Re: Modification Request Number 4 for the Glen Innes Wind Farm

ADDITIONAL SUBMISSION IN RELATION TO MODIFICATION REQUEST NO.4 BY THE GLEN INNES WIND FARM

Figure 4- Approved GIWF Mod-2 and proposed Mod-4 wind turbine comparison

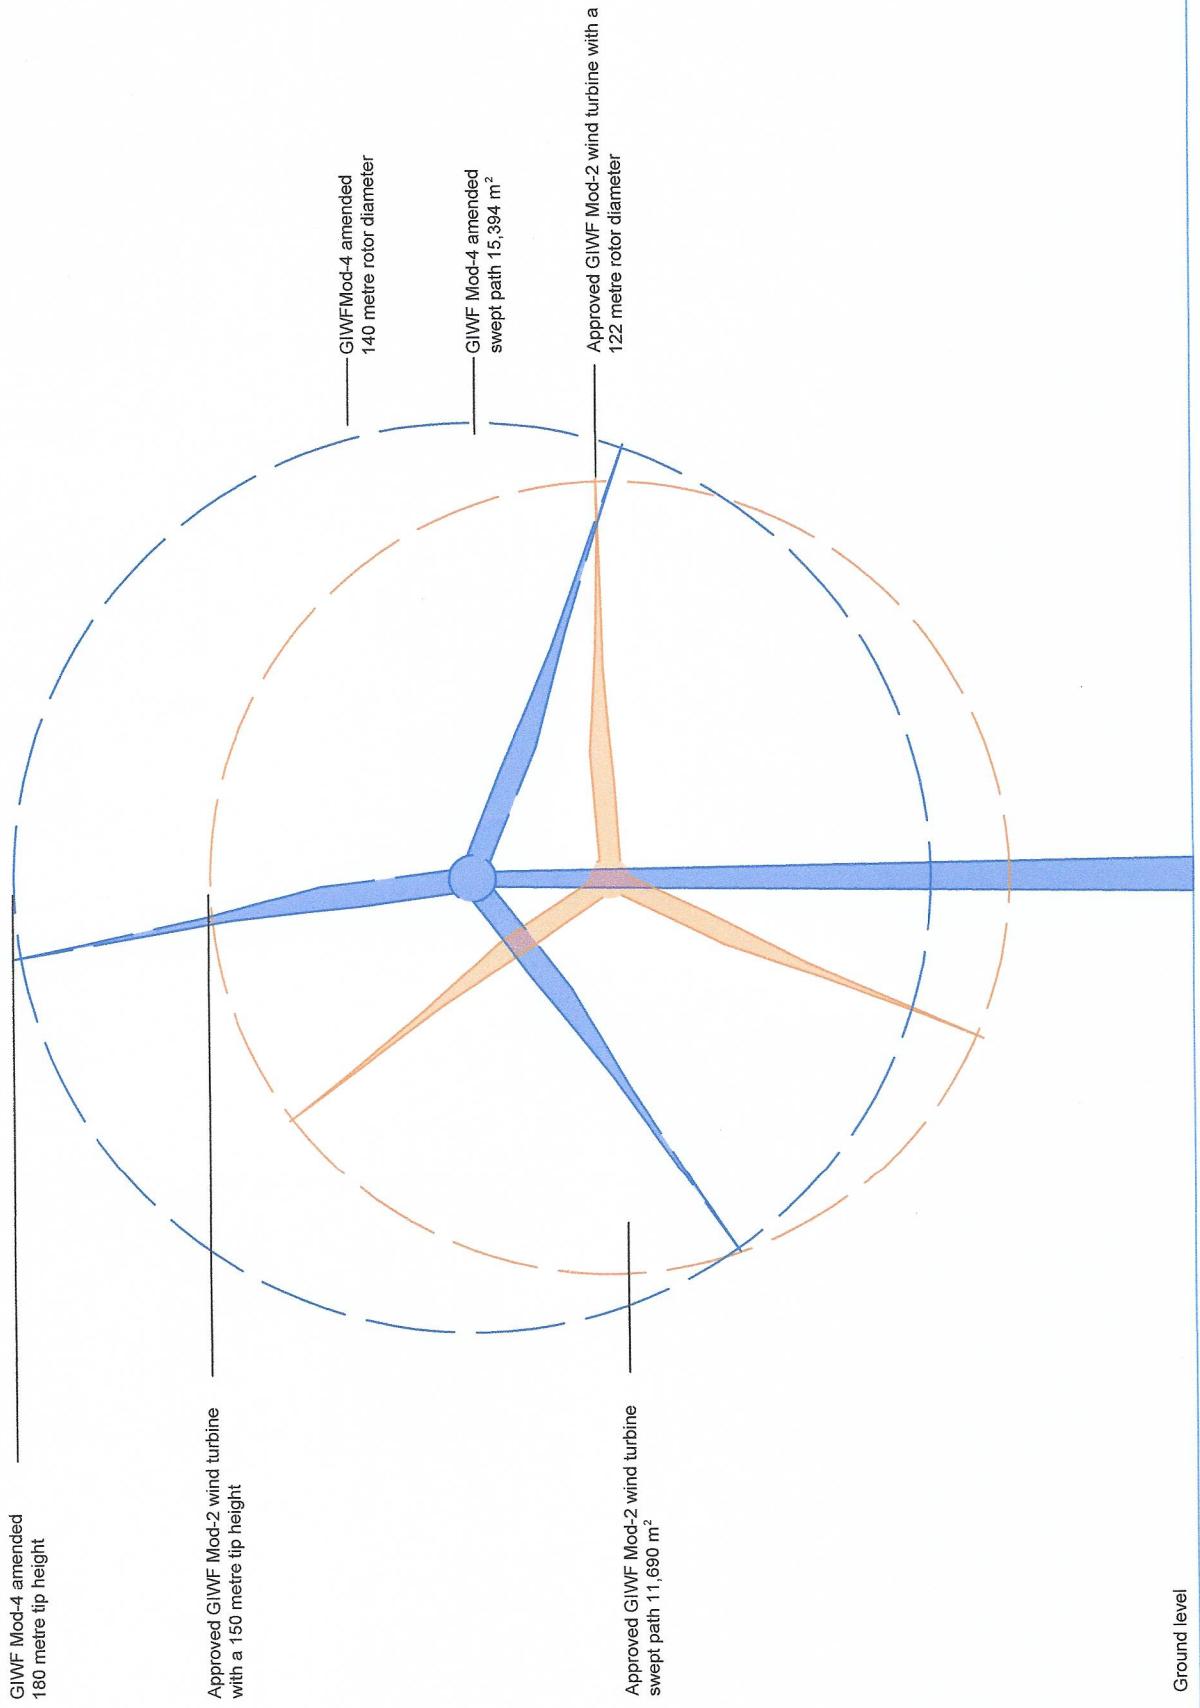
Visual increases of 32%, 24%, 20% and 15% will have a material/substantial Increased Visual Effect. Figures 4, 5 and 6 in GBD report (attached as pages 12, 13 and 14), which are attached, clearly illustrates this fact and as such Mod 4 cannot be approved.

AN AVERAGE REASONABLE PERSON LOOKING AT THE ATTACHED FIGURES 4, 5 AND 6 FROM THE GBD REPORT (ATTACHED AS PAGES 12, 13 AND 14) WOULD CONCLUDE THAT MOD 4 WOULD GIVE RISE TO AN INCREASED LEVEL OF VISUAL IMPACT.
